PROJECT REFERENCE NO.	SHEET NO.
R-3825B	EC-41/CONST.21
R/W SHEET NO.

REVISION DESIGNED BY ROADSIDE ENVIRONMENTAL UNIT 12/17/2020

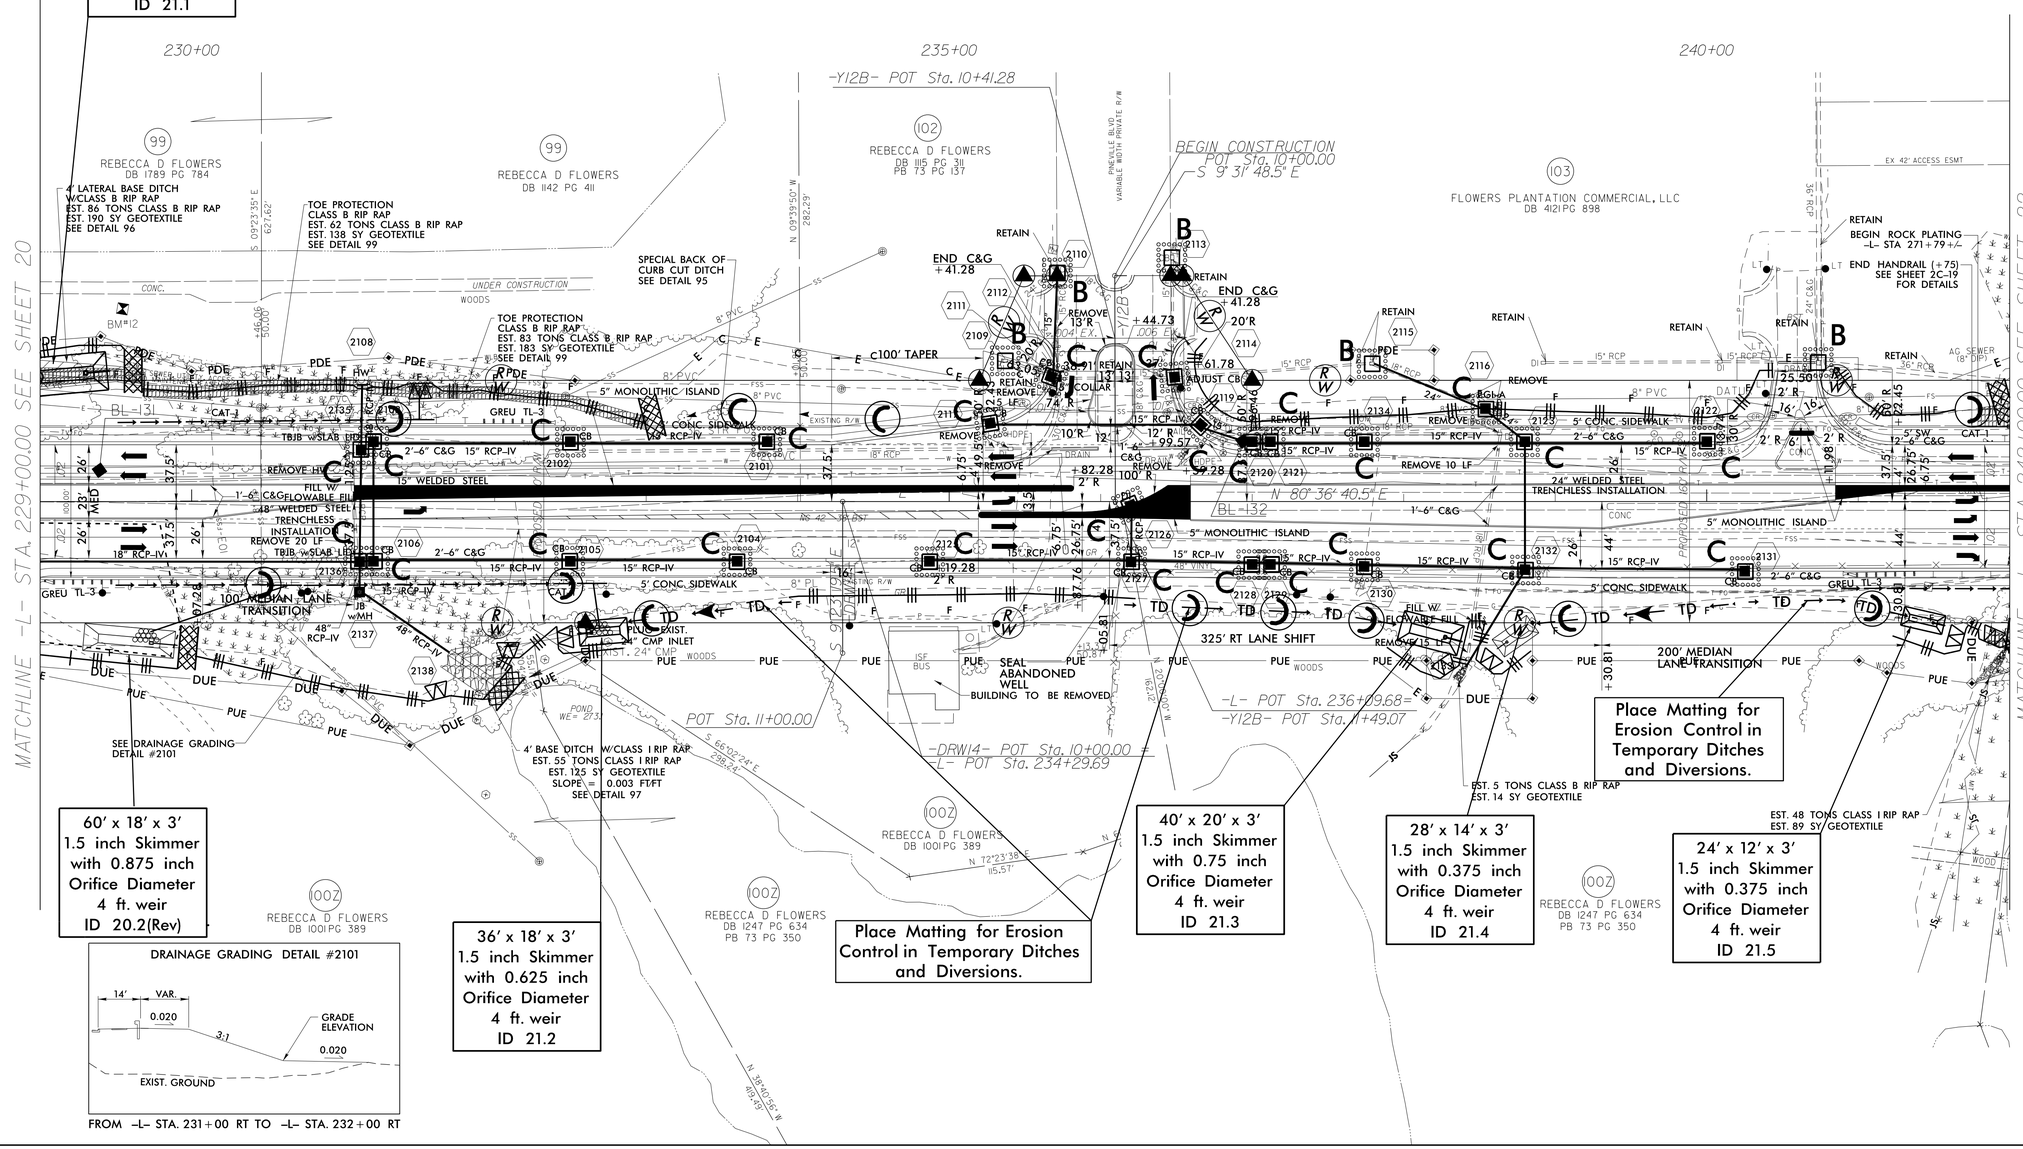
1 – ROW, PUE, PDE, AND EASEMENTS UPDATED ON PARCEL 100 FROM STA. 218+77 TO 244+77 (10/12/2018) TLH
10/16/2019 – CONSTRUCTION REVISION:REMOVED –DRW13– AT –L– STA. 228+86.87 TO 229+52.33 RIGHT. HYDRAULICS PIPE AND DITCH WAS REVISED FOR –DRW13– REMOVAL. HN
08/17/2020 – CONSTRUCTION REVISION:REVISED THE BERM WIDTH, SLOPES AND DRAINAGE TO TIE TO THE DEVELOPER'S SITE PLAN FROM –L– STA. 229+00 TO 233+00; AND ADDED A DRAINAGE GRADING DETAIL #2101. HN
